Town of Innisfil Certified Model

GROUND FLOOR PLAN 'A'
SEE PAGE 13. FOR AREA CHART

VA3 DESIGN

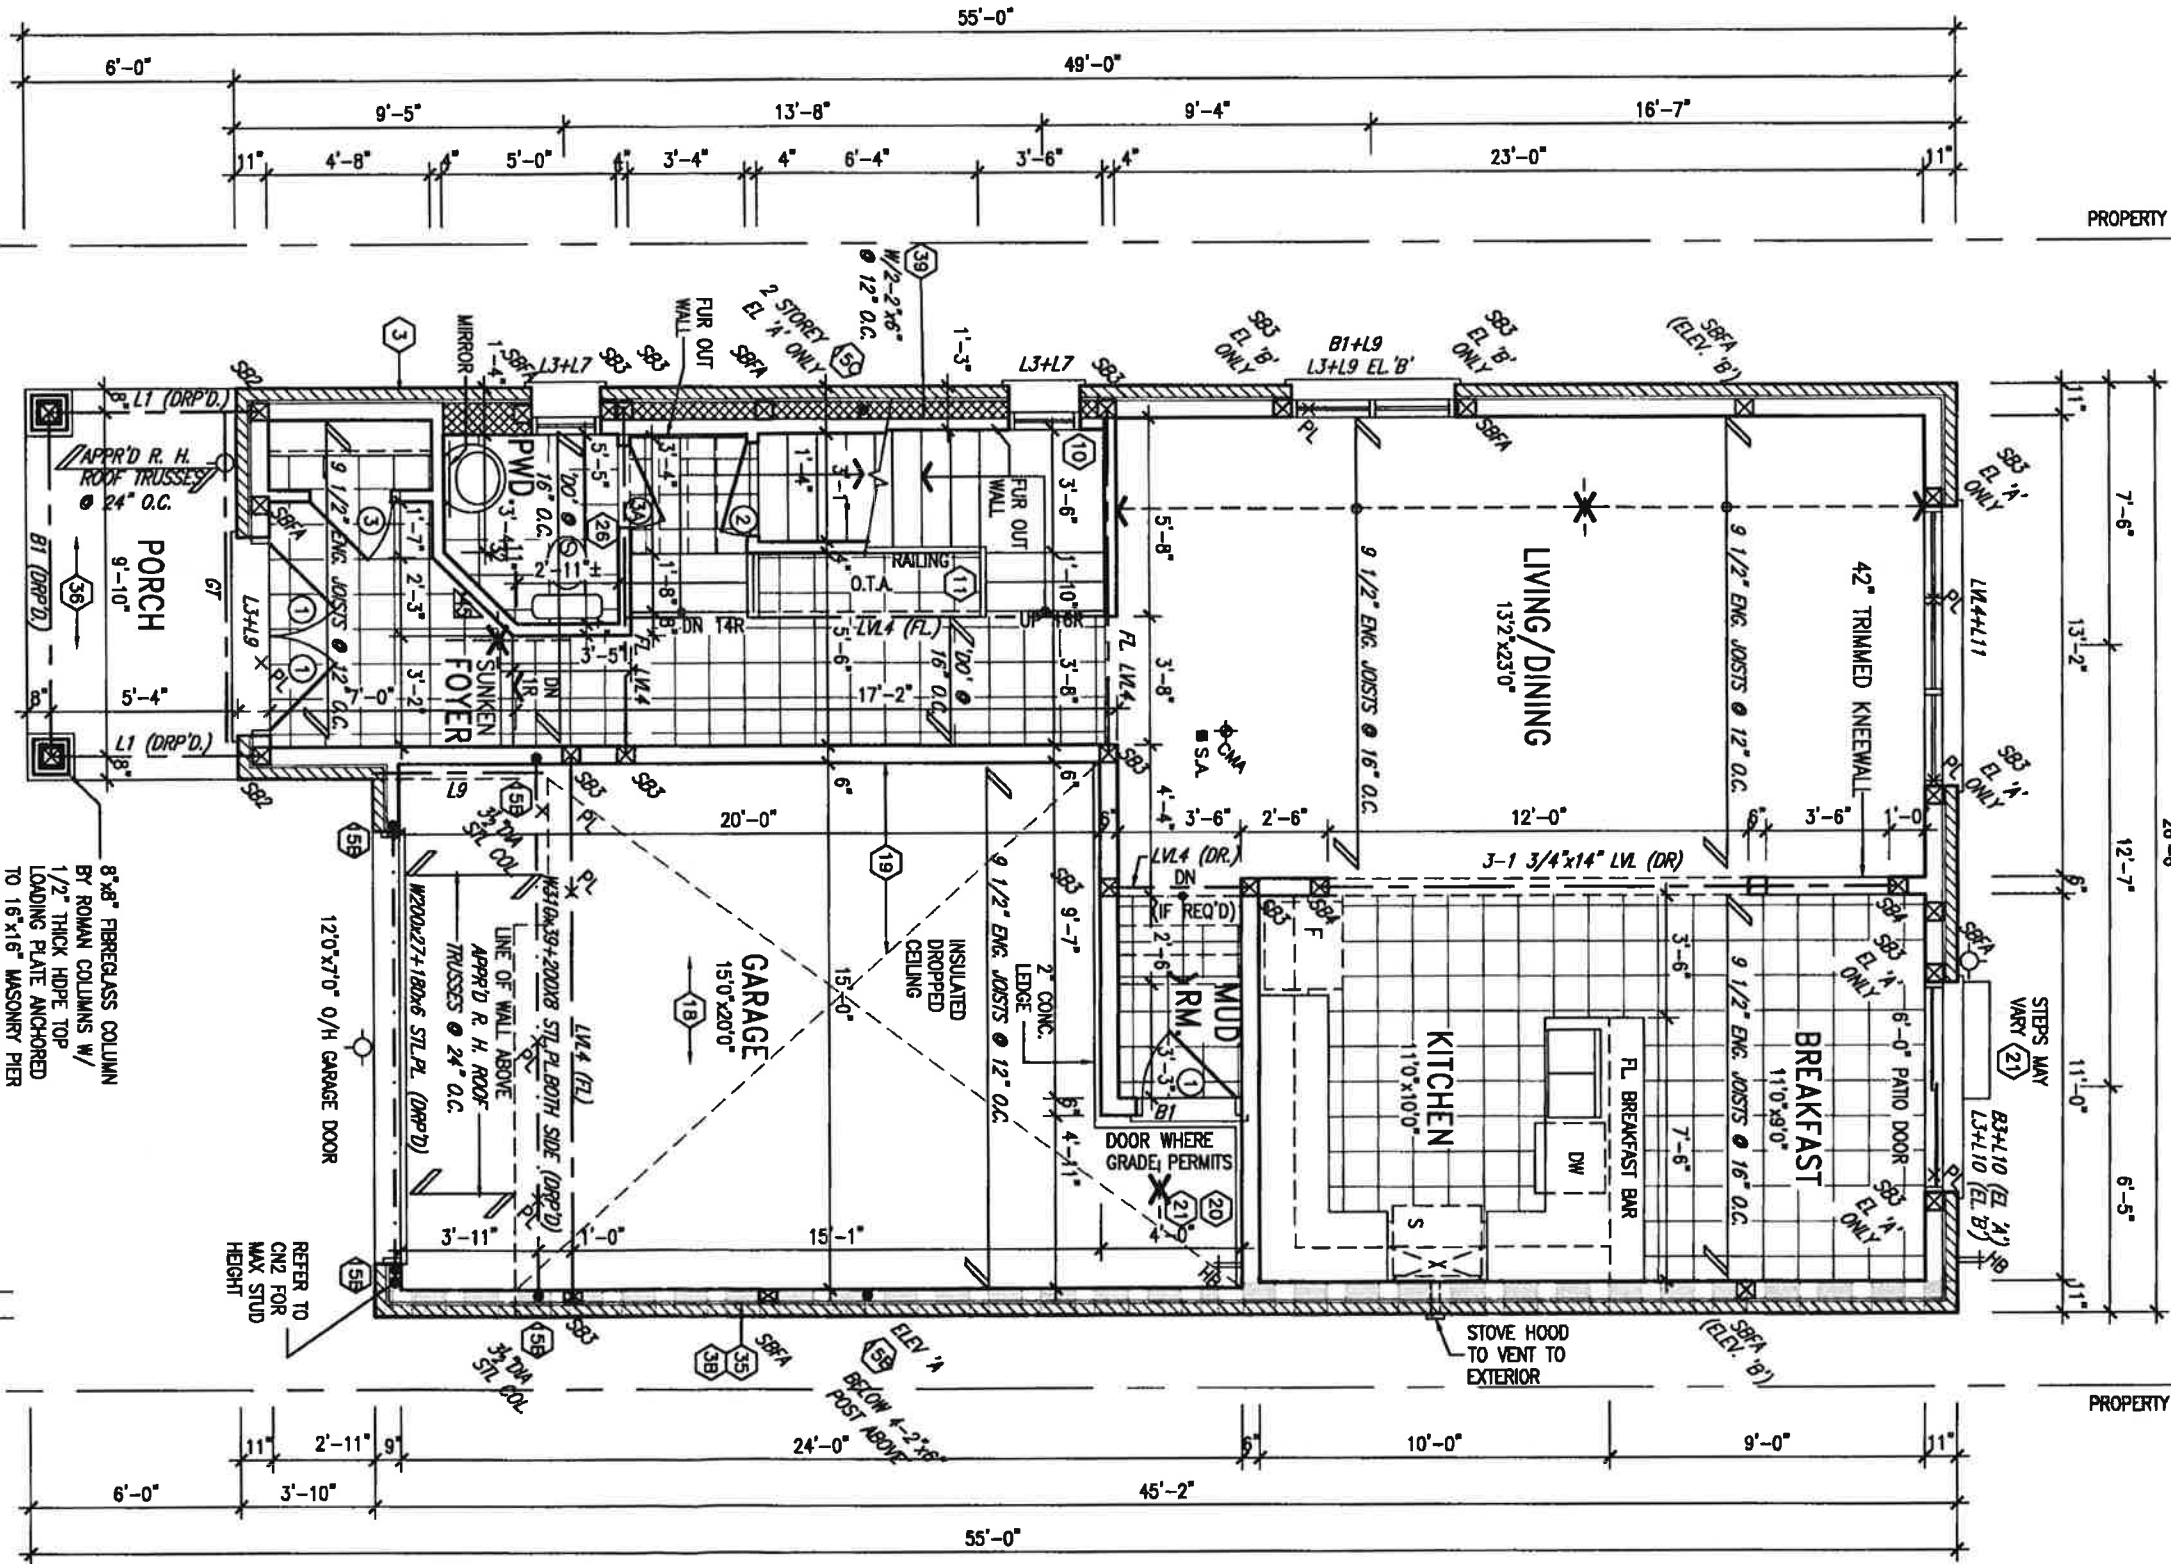
provide 4" of rigid insulation under slab for protection of footings on interior of cold cellar.

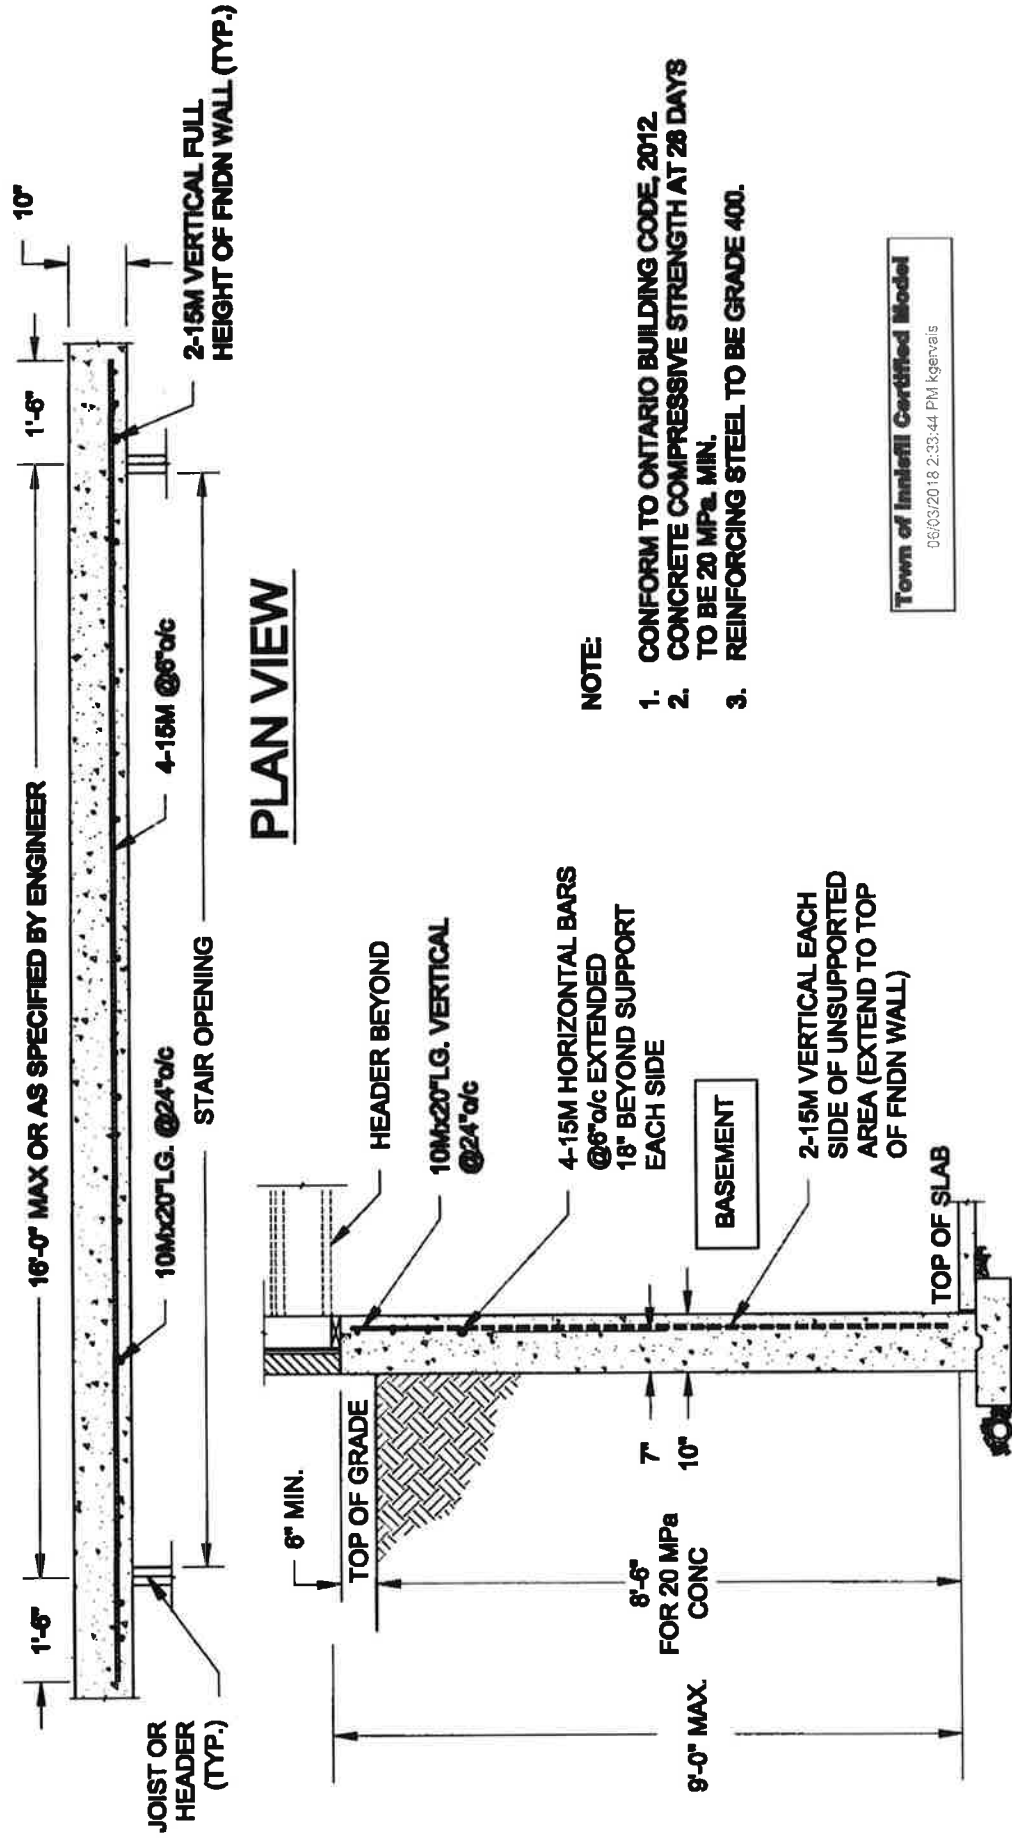
where patio stones are provided, ensure min landing depth of 2'-11" is achieved.
